title: **SITE PLAN PROPOSED**

project: DEMOLITION OF WOMBEWELL SHOOKER AND SOCIAL CLUB
RESIDENTIAL DEVELOPMENT OF TWO BLOCKS
OF 3NO. SELF CONTAINED APARTMENTS
MARSH STREET, WOMBEWELL S73 6AG

drawing no **02D.**

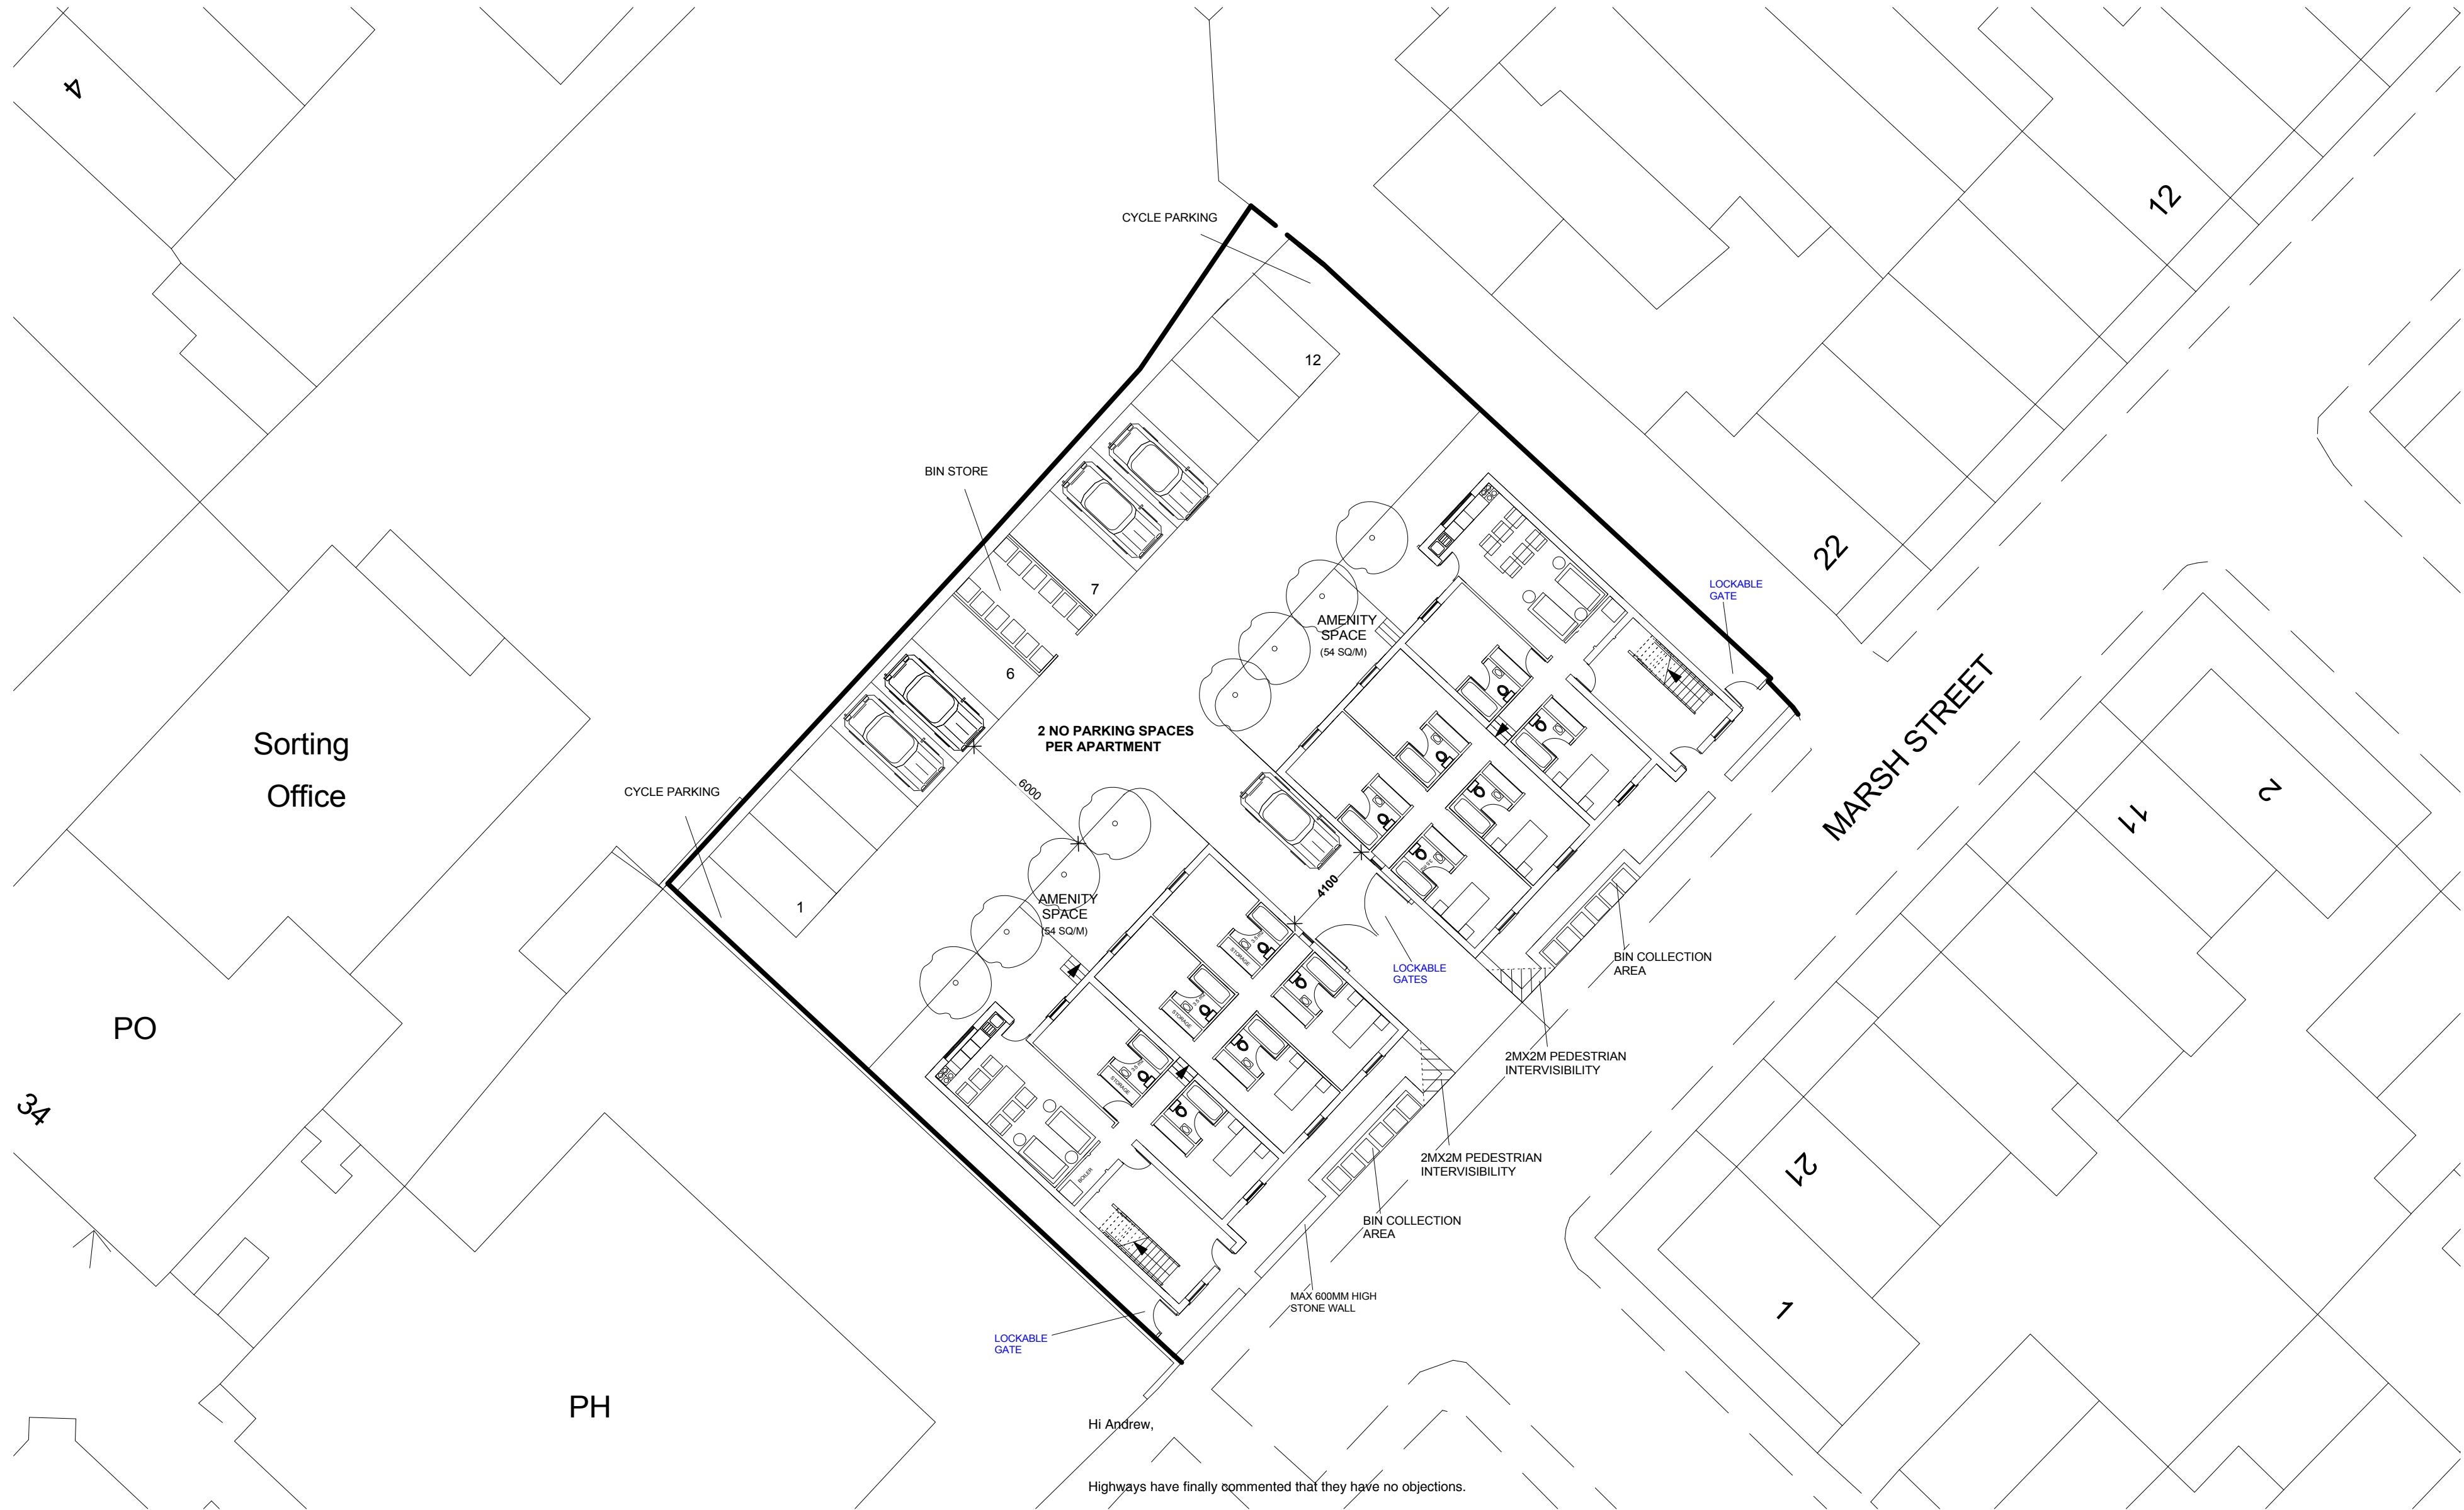
I have consulted the South Yorkshire Police Architectural Liaison Officer and he has made the following comments:

The flats would be more secure if they had a secure rear parking area and some defensible space around the front. Access around the sides of the development should be secured with a lockable gate or just fenced off, as close to the front building line as possible.

I can condition gate and fencing details if you are in agreement. Otherwise, if you could mark gates around the sides of the development on a plan that would prevent the need for a planning condition.
